STATE OF NORTH CAROLINA
DEPARTMENT OF TRANSPORTATION

July 8, 2020

Subject: **Request for Modification to the Regional General Permit Number 31, Section 401 Water Quality Certification, and Neuse Buffer Authorization for Improvements to Existing I-440 Beltline, from south of SR 1313 (Walnut Street) to north of SR 1728 (Wade Avenue), Wake County. WBS 35869.1.2. TIP U-2719**

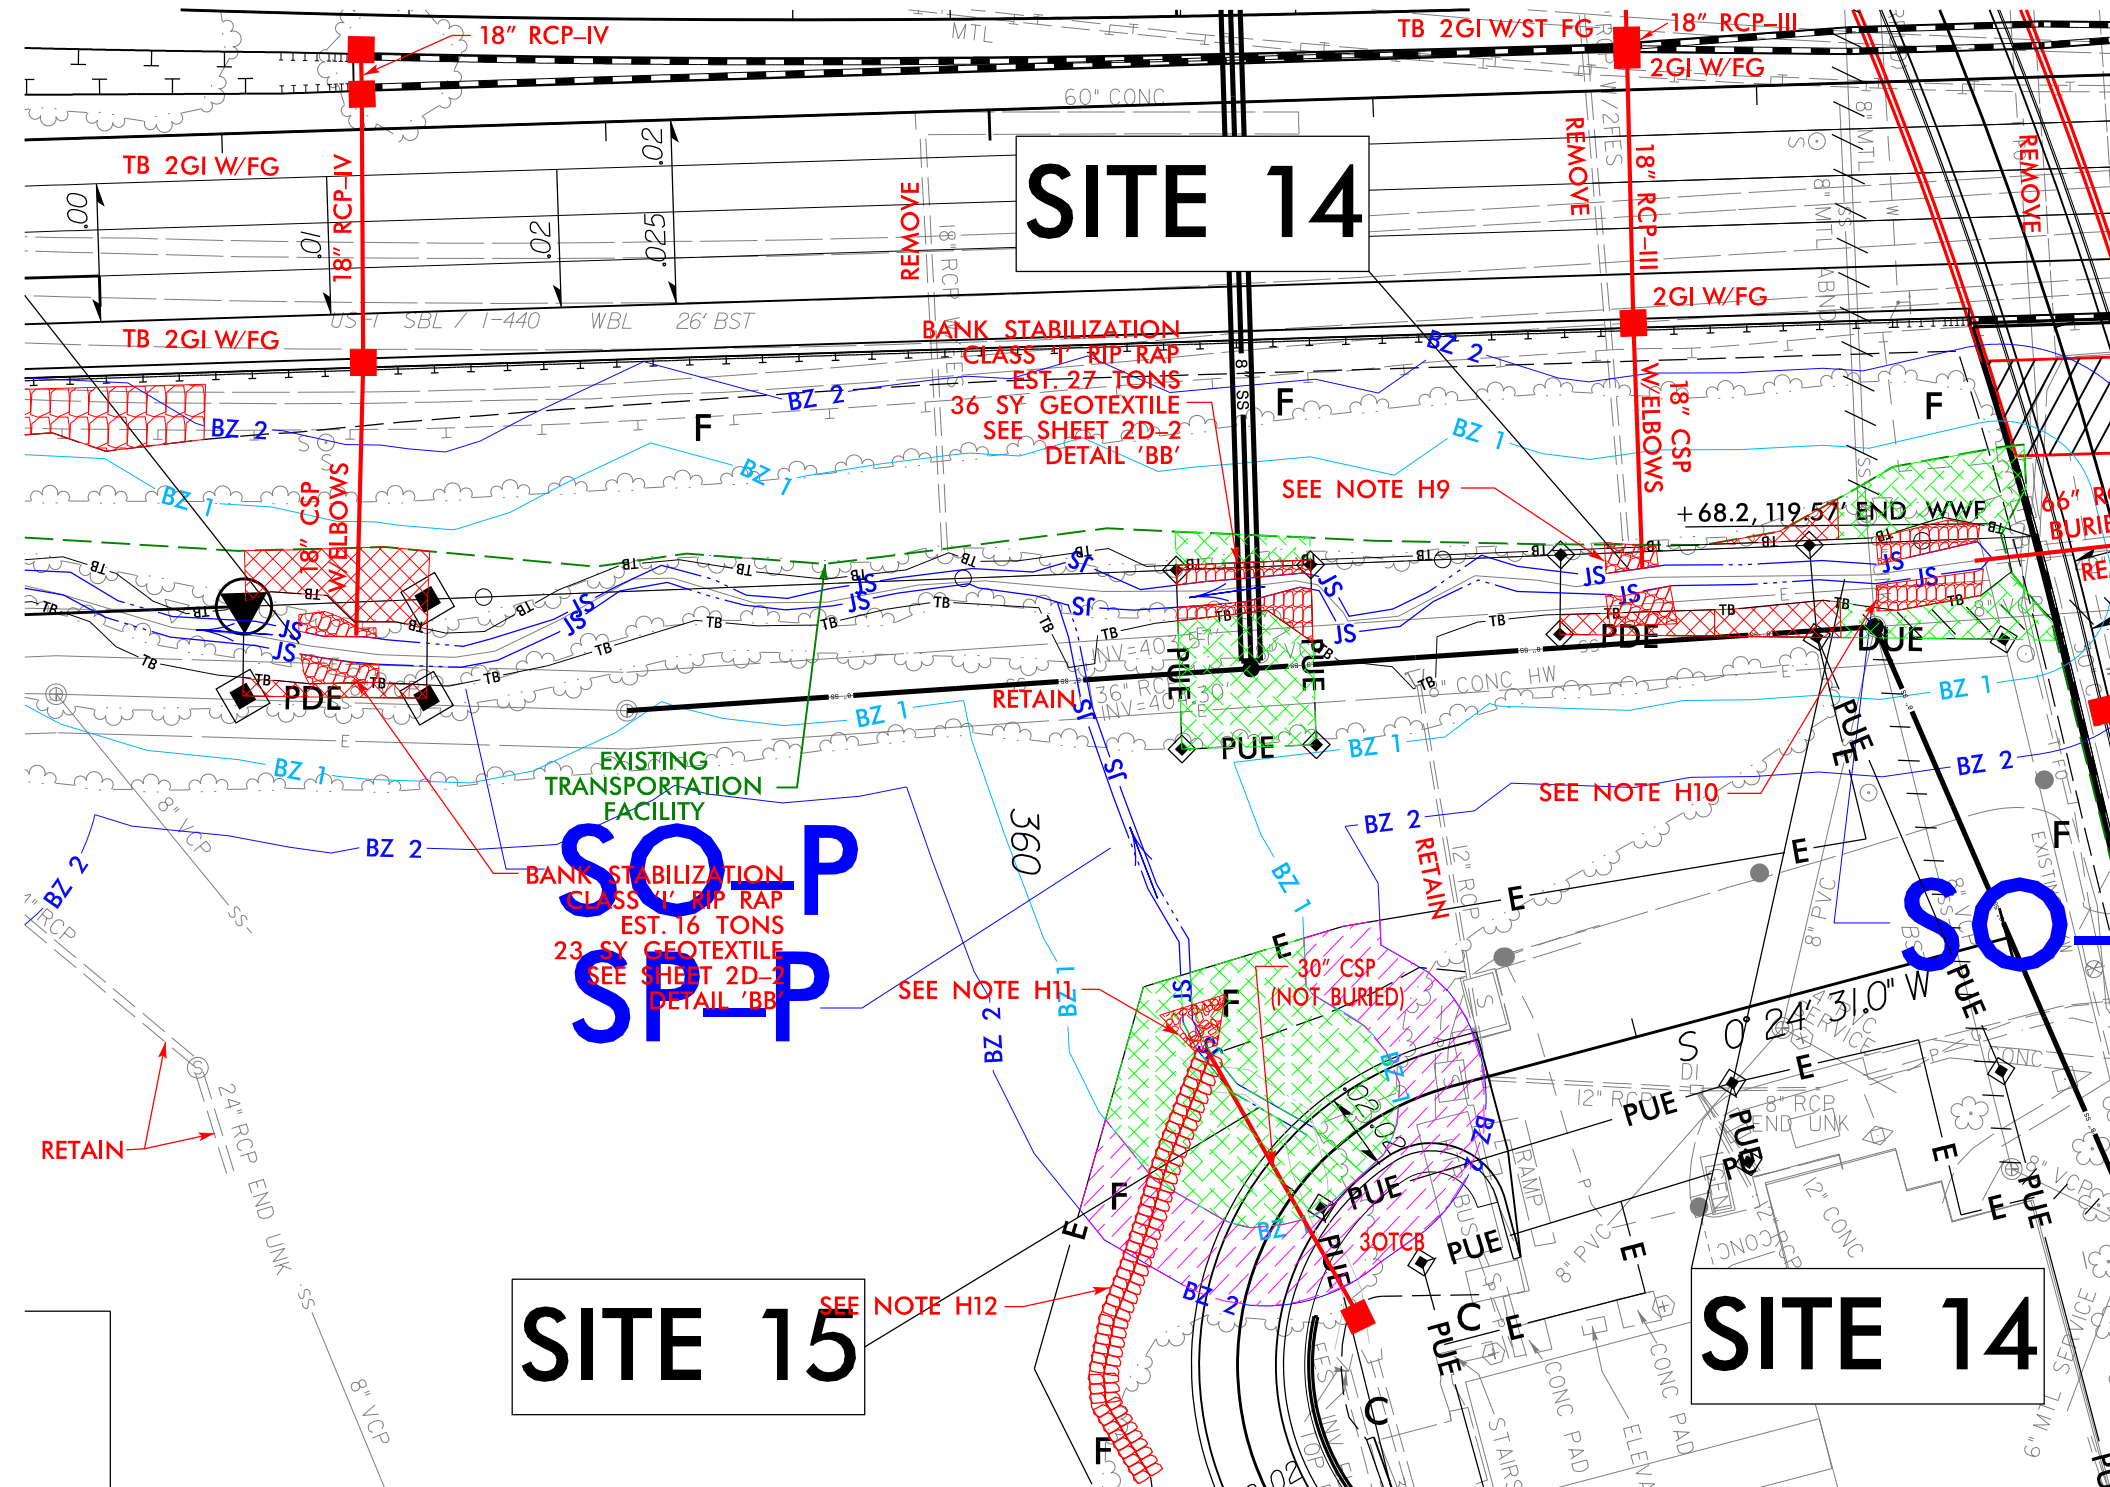
Site 14 (Sheet 18/18A) – Site 14 has an increase in permanent stream impacts and allowable buffer impacts due to a sewer line which will be bored under I-440. The increase in permanent stream impacts is due to bank stabilization being installed according to the utility recommendations. Bank stabilization impacts result in an additional 35 lf of permanent impact. Buffers will also be impacted by installation of the bank stabilization resulting in an additional 4,075 sq ft of impact in Zone 1 and 1,396 sq ft in Zone 2. This makes the total allowable impact in Zone 1 10,921 sq ft and Zone 2 is 2,780 sq ft for Site 14.
